UNITED STATES
NUCLEAR REGULATORY COMMISSION
REGION I
631 PARK AVENUE
KING OF PRUSSIA, PENNSYLVANIA 19406

IE Bulletin No. 80-20
Page 1 of 2

FAILURES OF WESTINGHOUSE TYPE W-2 SPRING RETURN TO NEUTRAL CONTROL SWITCHES

FIGURE 1

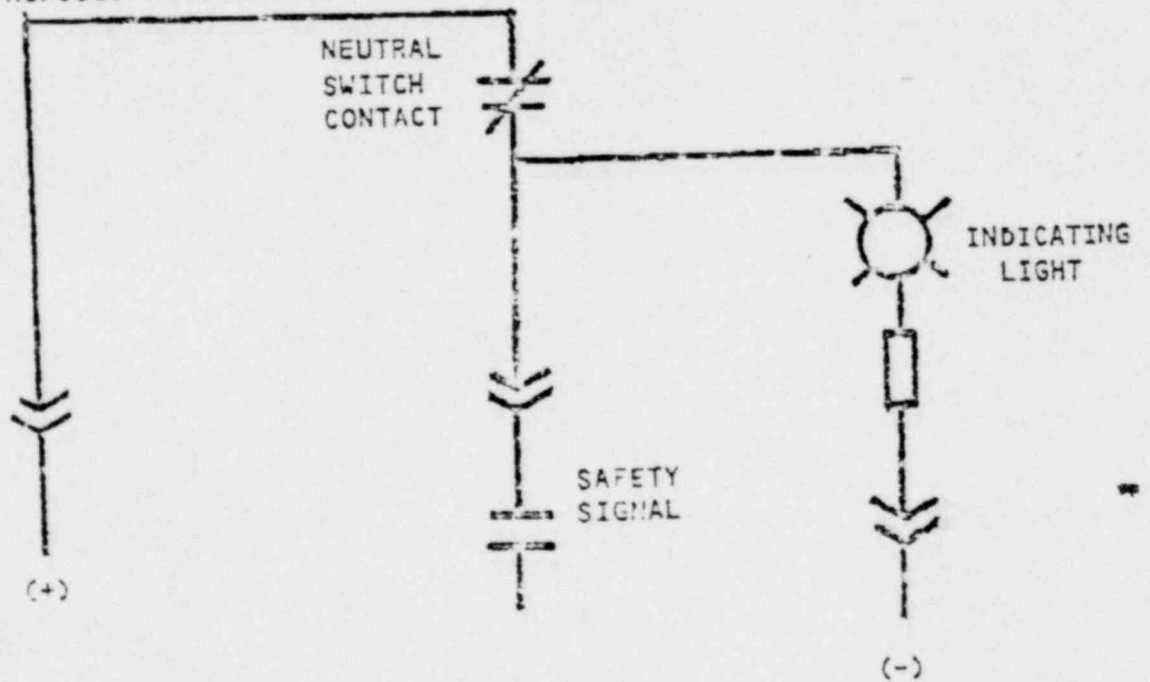
A review of this matter by Westinghouse led to the issuance of NSD Technical Bulletin No. NSD-TB-80-9 to the utility owners of all Westinghouse operating plants. The recommendations contained in the Westinghouse technical bulletin include: (i) testing the neutral position contacts of the subject W-2 switches for continuity, and (ii) rewiring of the indicating light circuit to permit the early detection of a neutral contact failure as shown in Figure 1.

Depending on how the indicating light circuit is wired, loss of continuity thru the neutral position contact of a W-2 switch could remain undetected until the equipment associated with the switch were called upon to operate. Since such a failure would be equivalent to by-passing the system associated with the switch, consideration should be given to rewiring the switches used in safety-related applications as shown in Figure 1. Such rewiring would provide an acceptable means for detecting contact failure, provided the indicating light is in the control room and readily visible by the operator. If the indicating light is not so located, consideration should be given to annunciating the neutral position contact failures at the control room to alert the operator of the inoperable status of a safety-related system. In addition, consideration should be given to adding redundant contacts to the W-2 switches or to replacing the W-2 switches with others having a more positive contact wiping action.

3. Licensees of operating plants and holders of construction permits shall describe the longer term corrective measures planned and the date by which such measures will be implemented by actual installation or by design change, as appropriate. As a minimum, the longer term corrective measures should include rewiring the indicating light as shown in Figure 1 provided the light is readily visible to the control room operator. If not, failures of the neutral position contacts should be annunciated in the control room.

REWIRING OF INDICATING LIGHT CIRCUIT OF W-2 SWITCHES
AS RECOMMENDED BY WESTINGHOUSE TECHNICAL BULLETIN NSD-TB-80-9
